REGIONAL REVIEW FINDING

ARC REVIEW CODE: R605231

Submitting Local Government: City of Buford
Name of Proposal: Buford Jubilee

Review Type: Development of Regional Impact

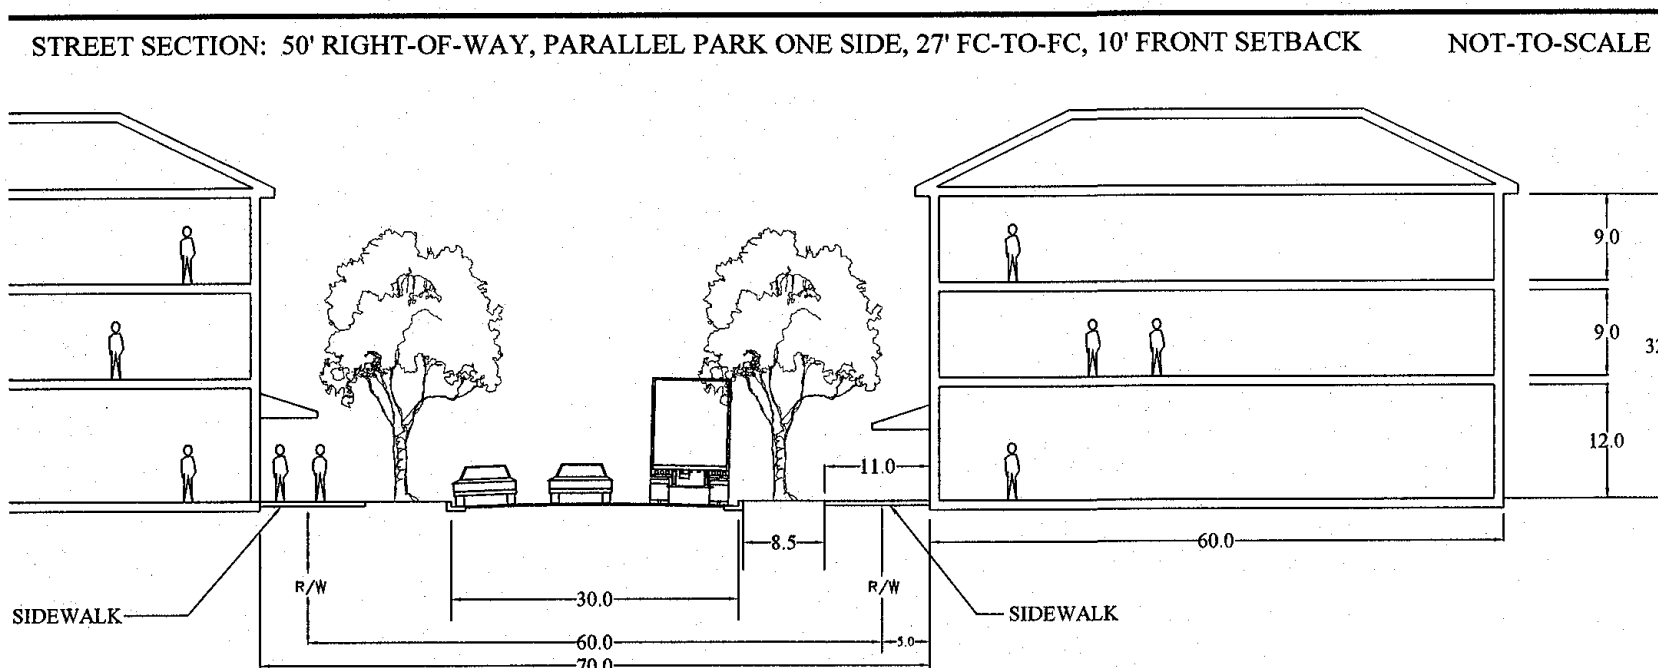
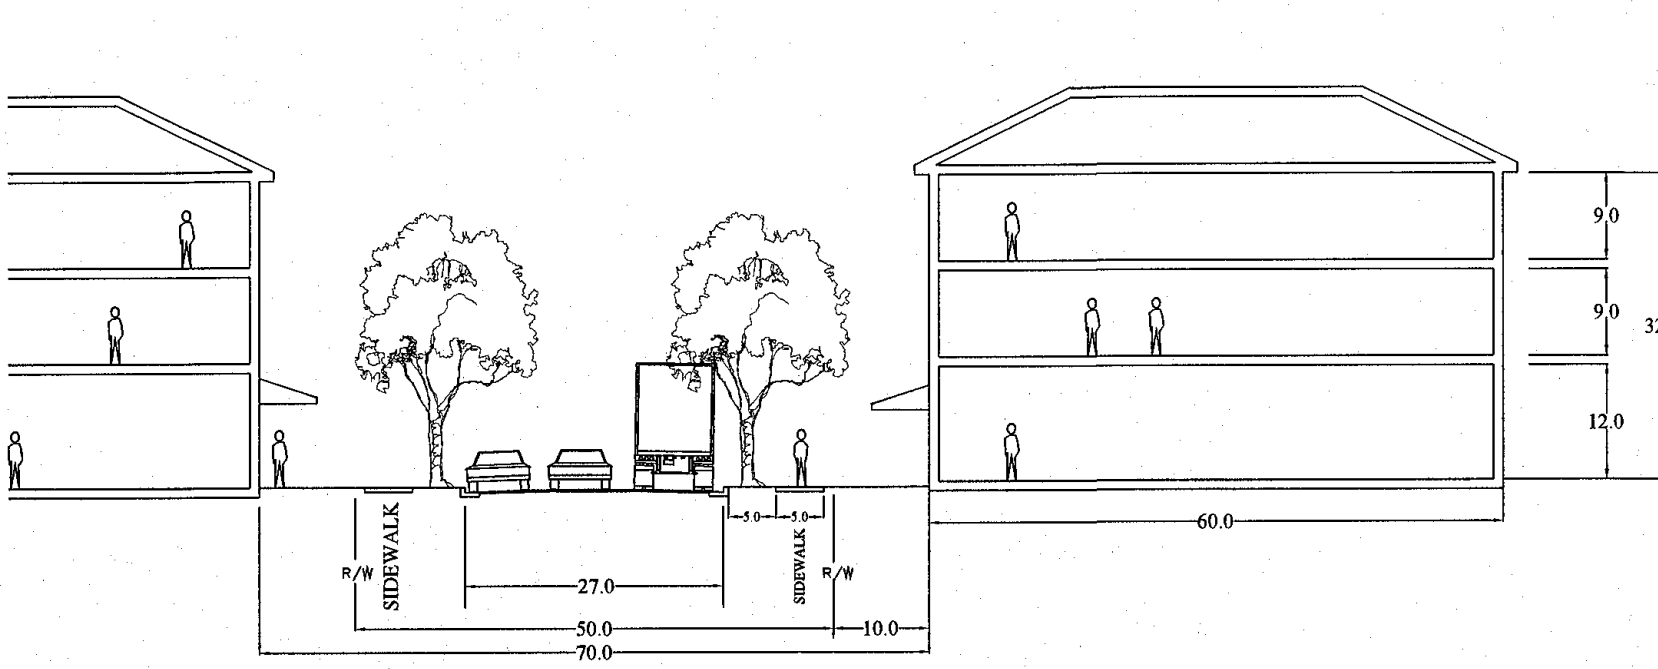
Internal street connection is important both locally and regionally. The proposed development provides good internal connections by establishing a grid system. Satellite Boulevard is essentially extended into the development and provides connections to potential future development on the other side of Maddox Road. Providing this connection is essential to the overall street network in the area by giving individuals more choices, opportunities, and connections to reach destinations. It will provide an alternative route to the area between Maddox Road and Hamilton Mill Road besides Buford Highway.

The site plan illustrates good pedestrian design by placing building along the street frontage and parking behind and decked, sidewalks on both sides of the street, landscaping, and adequate and convenient access to the community space for all the residents of the development.
